Proposed Front Elevation 1:40@A3

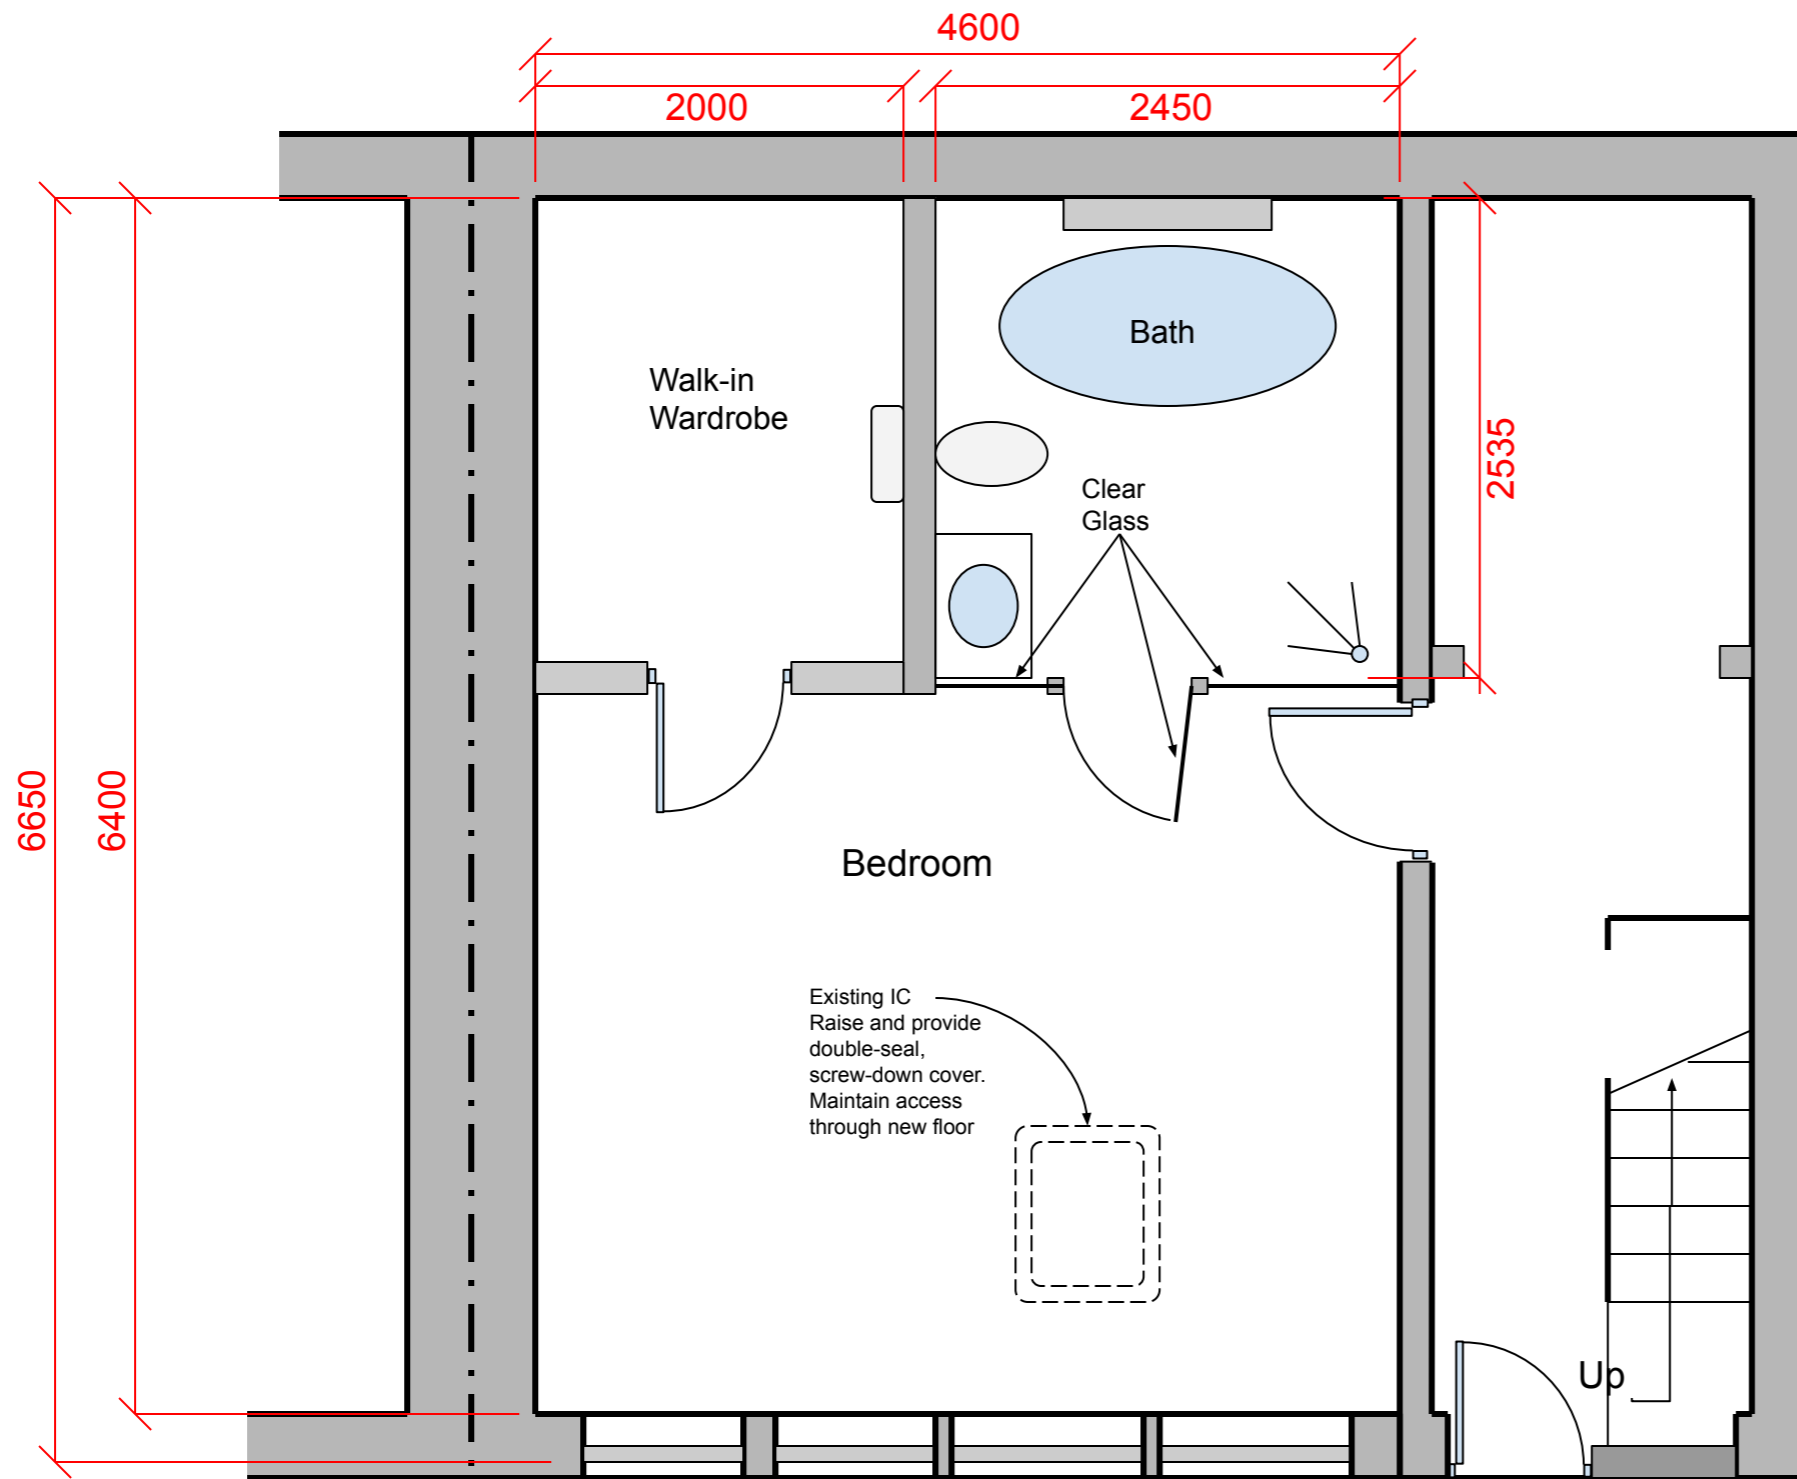
Existing metal casement windows to be replaced by **double-glazed wood casement windows**, with panelling as shown, painted in **white**.

(Previously approved application specified a change to sliding sash windows.)

Casement windows allow a more square panel shape, and closely match the central windows of the warehouse-style buildings on the other side of the road.

As per previous application, existing central window to be replaced by French doors and Juliet balcony, except that it will have panels to match the windows.

Garage door facade and front door to be timber painted a grey or black colour.

New wall area to be rendered to match existing wall, as per previously approved application.

Proposed Ground Floor Plan 1:40@A3

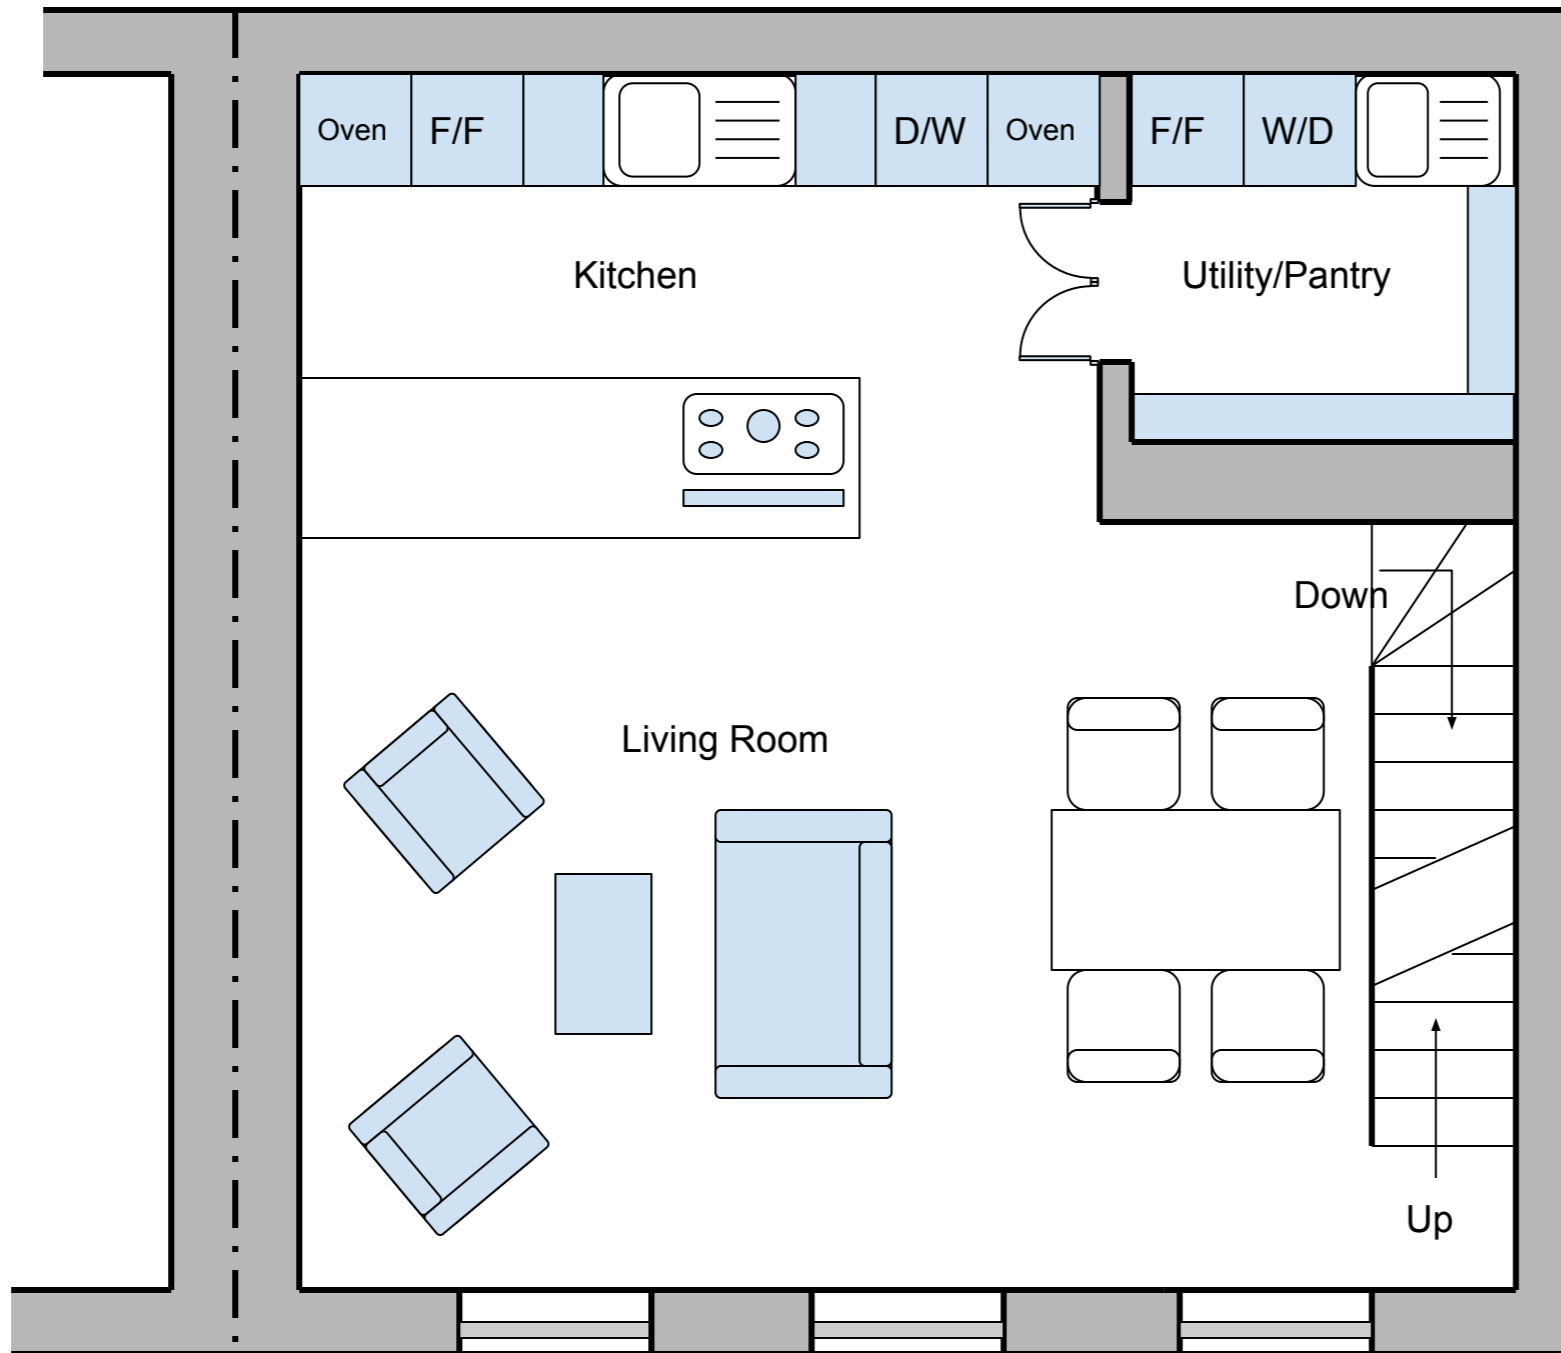
Planning notes:
 Previously approved application was for removal of the wall between garage and hallway and installation of kitchen and living room. The change here is to not remove the wall, use the existing doorway, (with door reversed) and install a bathroom and bedroom in the space of the garage.

Proposed First Floor Plan 1:40@A3

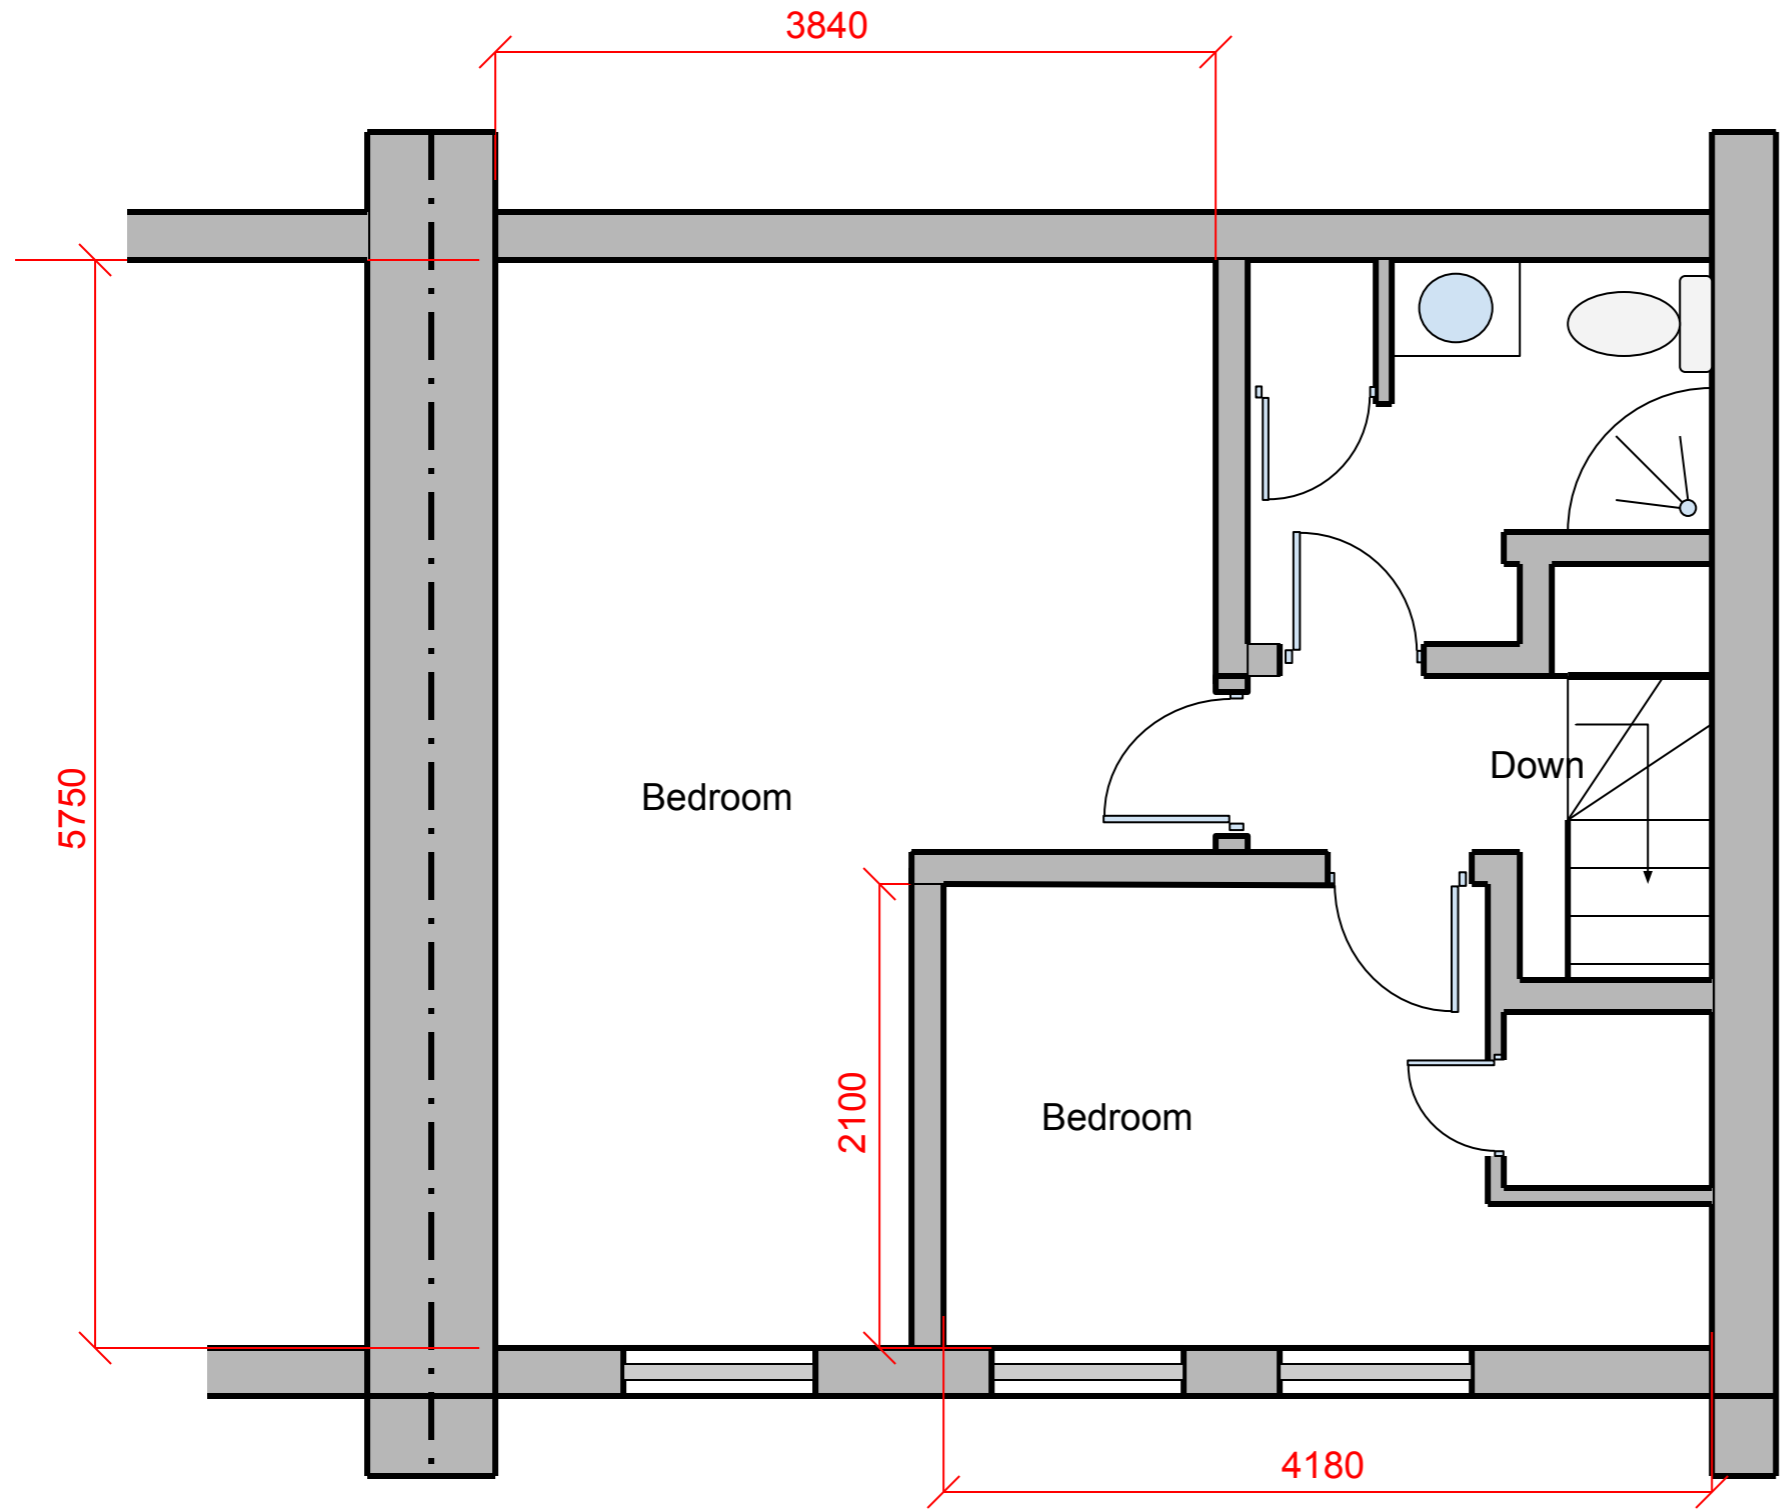
Planning Notes:
 Previously approved application was for a bedroom and bathroom. The change here is to remove the existing wall between the stairs and the living room, with structural engineer's guidance, to create an open-plan living/dining/kitchen area, with appropriate fire safety considerations. The existing kitchen becomes a utility room/pantry.
